CIVIL ENGINEERING REPORT INCORPORATING WATER CYCLE MANAGEMENT STRATEGY

SSD-36138263: AUGUSTA STREET WAREHOUSE & DISTRIBUTION CENTRE

AUGUSTA STREET, BLACKTOWN, NSW

Figure 5 – Basin 2 & 3 and areas where solar access is reviewed in section.

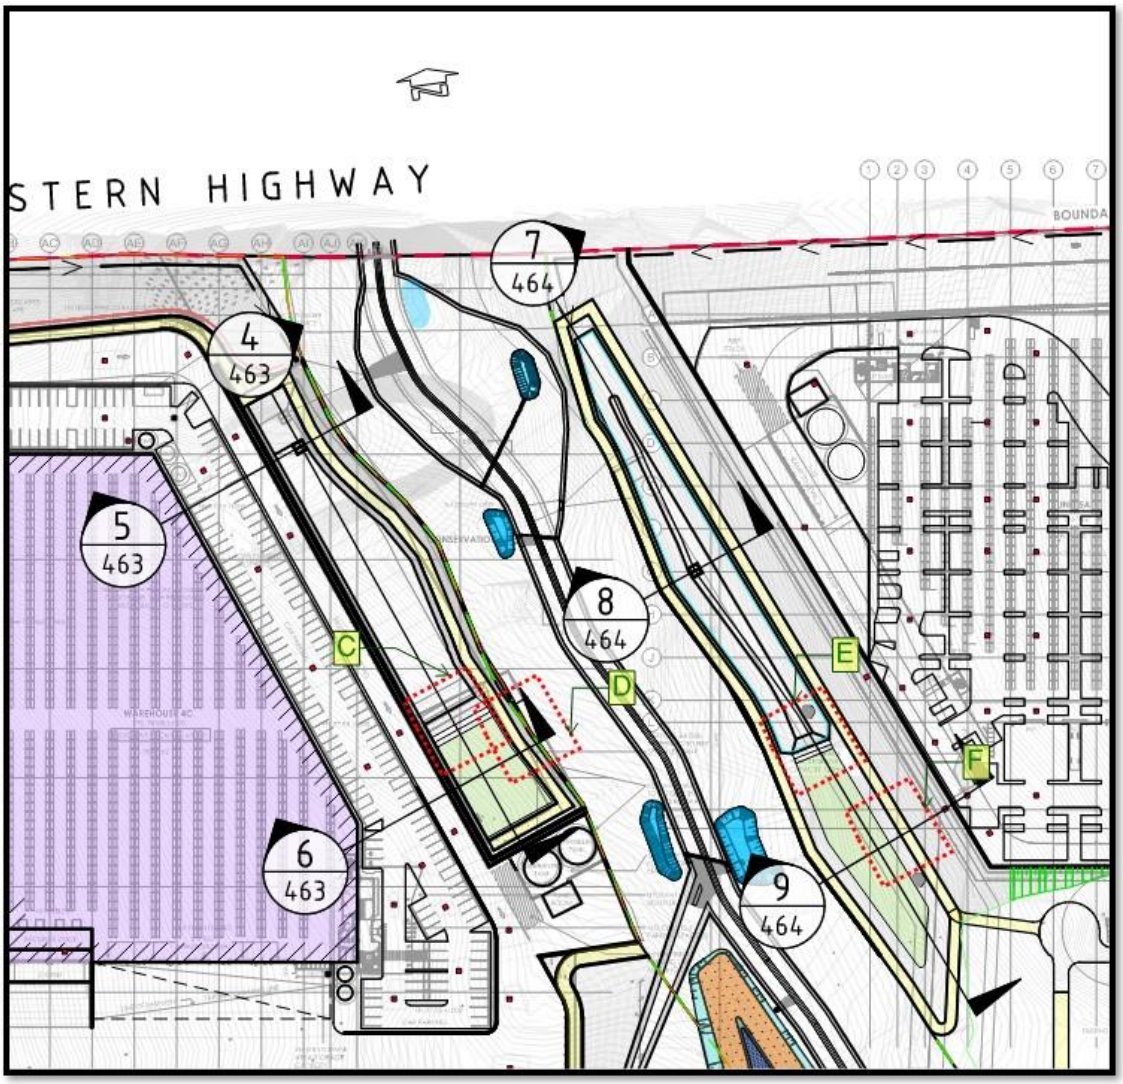
b)	the details of the proposed bioretention & detention basin shall be provided including details of the control pit, orifice level weir level and cross-section of the basins etc in both warehouse 3, 4, 5 & 6. The required details can be found in Council's Engineering Guideline for Development and WSUD Standard drawing A(BS)175M. Secondly, the longitude section of the access track shall be provided to prove the gradient is not more the 10%.	Reference should be made to drawing CO13904.03-SSDA465, that formed part of the latest submission, for a summary of the proposed bioretention & detention basin, control pits, orifice level weir levels, designed in accordance with Council's Engineering Guideline for Development and WSUD Standards. Maintenance access tracks will be designed during the detail design stage. A note is added to all stormwater drainage drawings at basins noting that all access tracks will be designed to have a maximum gradient of 10%.

An additional review of the architectural shadow study (referenced 220207-DA-003, dated Aug 2023) have been conducted. Bioretention Basin number 3 experience shadowing from warehouse 5 between 9am and 12pm. Refer to figure
